RESPONSE TO AUDIT ISSUES

APR1400 Topical Reports

Docket No. PROJ0782

Audit Issues No. 27-k

Figure 1. Nodalization of Pressurizer Surge Line

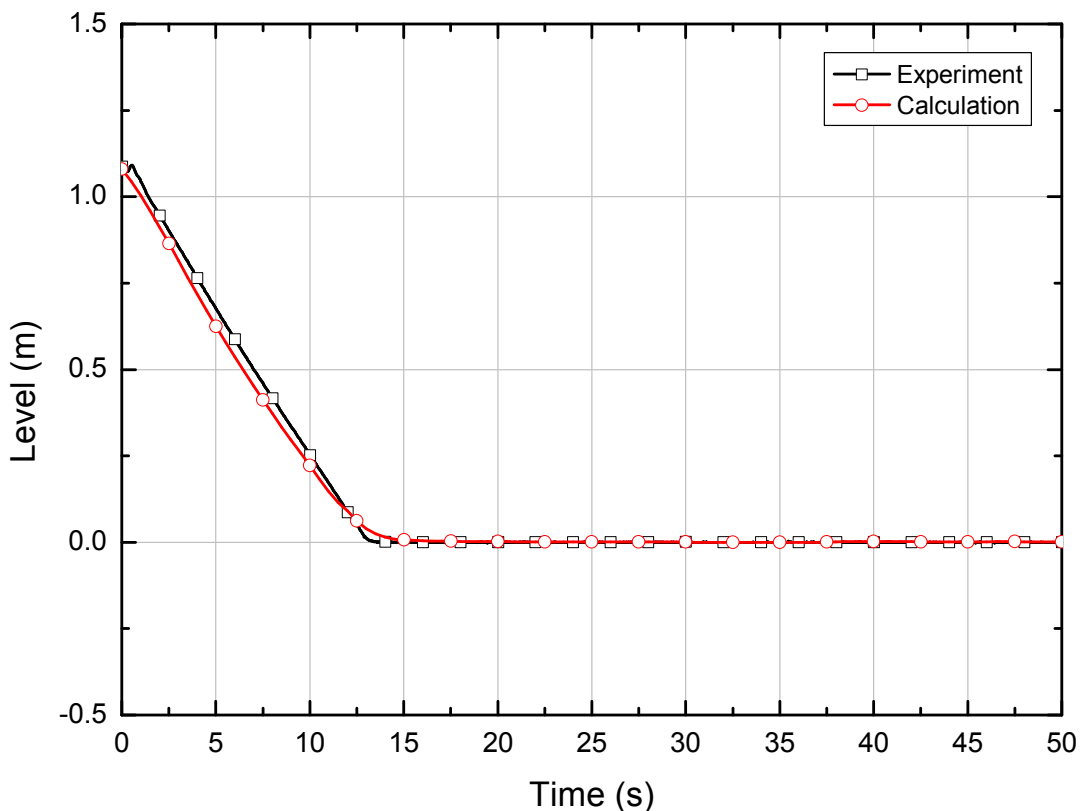
- k. In order to adequately simulate the depletion time of the pressurizer and liquid drainage during the blowdown period, the nodalization of the pressurizer surge line should be consistent with the actual plant geometry. However, the description for the pressurizer surge line nodalization is not provided in Section 4.2.1 of the topical report. According to the RELAP5 base model input deck, the surge line is modeled using a single inclined hydraulic component. Additionally, the loss coefficient through surge line pipe is set to be computed by the code which neglects the turns and orientation changes in the line. Justify the selected nodalization and loss coefficients including any references to nodalization sensitivity studies comparing the pressurizer flow into upper plenum against the available special effects tests and/or integral effects tests data.

The surge line of pressurizer is modeled as a SNGLVOL component as show in Figure 1 and the detailed information of surge line are as follows.

In order to predict the depletion of pressurizer, the pressurizer and surge line are modeled as PIPE component with []TS and SNGLVOL component respectively to reflect the assessment result against LOFT test. Figure 2 shows the pressurizer level. It is confirmed that the calculation result using this nodalization is adequately predicted comparing to the result of LOFT test. Based on the result, the nodalization of pressurizer and surge line mentioned above is used in the plant calculation.
